Application No.: 10/590,471
Amendment Dated: March 5, 2010
Reply to Office Action of: January 5, 2010

MAT-8885US

Amendments to the Drawings:

Remarks/Arguments:

FIG. 1

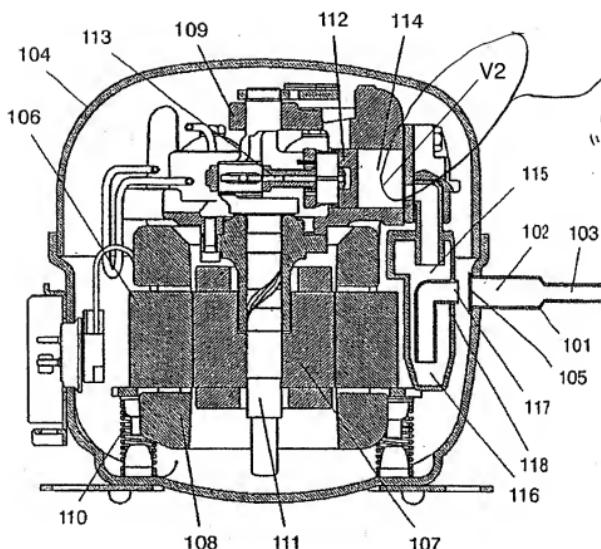
Page 2 of the Office Action sets forth "[t]he drawings are objected to...because they do not include the following reference sign(s) mentioned in the description: V2." Additionally, page 3 of the Office Action sets forth "[t]he disclosure is objected to because...[t]he specification contains reference numeral V2, not found in the drawings, as detailed above." Applicants note that the replacement sheet provided with the previous response was included in error. Applicants herewith provide the correct replacement sheet for FIG. 1, which includes the reference sign "V2".

The Office Action further sets forth that "applicant is required to submit a marked-up copy of each Replacement Sheet including annotations indicating the changes made to the previous version." Applicants herewith provide an annotated replacement sheet for FIG. 1. The annotated sheet indicates that a new reference sign "V2" has been added to FIG. 1, along with an associated lead line. The new reference sign and lead line are circled on the annotated sheet. No other changes are made to FIG. 1.

The attached replacement sheet of drawings includes changes to Figure 1. This sheet replaces the original sheet.

The attached annotated replacement sheet indicates the changes made to Figure 1.
